UNITED STATES PATENT AND TRADEMARK OFFICE

Office Action Summary

10/521,921

DETAILED ACTION

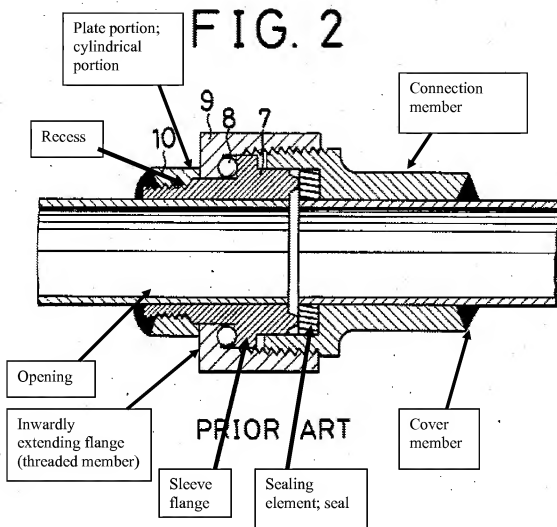
With regard to claim 1, and as seen in Figure 2 below, Totani discloses a fluid connection assembly for establishing a connection with a fluid supply pipe extending from a rear face of a panel to a front face of the panel, the assembly comprising a connection member engageable with the fluid supply pipe at the front of the panel; and means for connection of the fluid pipe to the connection member, comprising a support member (10) adapted to be fixed to the panel at the front face thereof, a threaded member (9) supported by the support member and rotatable relative to the support member for engaging the connection member, and a compression fitting operable from the front of the panel and comprising a sealing element deformable responsive to tightening of the threaded member to establish a seal between the fluid supply pipe and the connection member.

With regard to claim 2, and as seen in Figure 2 above, Totani discloses the connection member having screw threaded engagement with the threaded member (9), and the compression fitting includes the sealing element deformable between the threaded member and the connection member to establish a seal between the fluid supply pipe and the connection member.

With regard to claim 3, and as seen in Figure 2 above, Totani discloses the connection member being adapted to have a shower head or hose connected to it.

With regard to claim 4, and as seen in Figure 2 above, Totani discloses a cover member adapted to engage with the assembly and to conceal the assembly.

With regard to claim 5, and as seen in Figure 2 above, Totani discloses the support member (10) comprising a plate portion *abutting the front face of the panel* and a recess *that extends past the front face of the panel toward the rear face of the panel*.

With regard to claim 6, and as seen in Figure 2 above, Totani discloses a sleeve (7) disposed between the fluid supply pipe and the recess of the support plate, wherein the sleeve includes a flange that corresponds with a flange of the threaded member for holding the threaded member in a desired axial position relative to the support plate while providing for rotation of the threaded member relative to the support plate.

With regard to claim 7, and as seen in Figure 2 above, Totani discloses the sealing element being disposed about the fluid supply pipe between the sleeve on a first axial end and the connection member.

With regard to claim 8, and as seen in Figure 2 above, Totani discloses the threaded member (9) comprising a threaded nut including an inwardly extending flange corresponding to the flange of the sleeve for holding the desired axial position of the threaded member onto the support.

With regard to claim 10, and as seen in Figure 2 above, Totani discloses a fluid connection assembly comprising:

- a support (10) attachable to a panel that includes an opening for a fluid supply pipe;
- a threaded member (9) supported on the support and rotatable relative to the support;
- a conduit engageable with the threaded member for directing water to a hydraulic device;
- and
- a seal for assembly to the fluid supply pipe that is compressible responsive to the conduit being threadably received by the threaded member.

With regard to claim 11, and as seen in Figure 2 above, Totani discloses the support plate including a sleeve (7) disposed between the fluid supply pipe and the opening in the support for rotatably supporting the threaded member.

With regard to claim 12, and as seen in Figure 2 above, Totani discloses the seal being disposed around the fluid supply pipe and between the sleeve and the conduit.

With regard to claim 13, and as seen in Figure 2 above, Totani discloses the support including a face portion *that abuts the panel* and a cylindrical portion *that extends through the panel about the fluid supply pipe*.

With regard to claim 14, and as seen in Figure 2 above, Totani discloses the face portion being attachable to the panel.
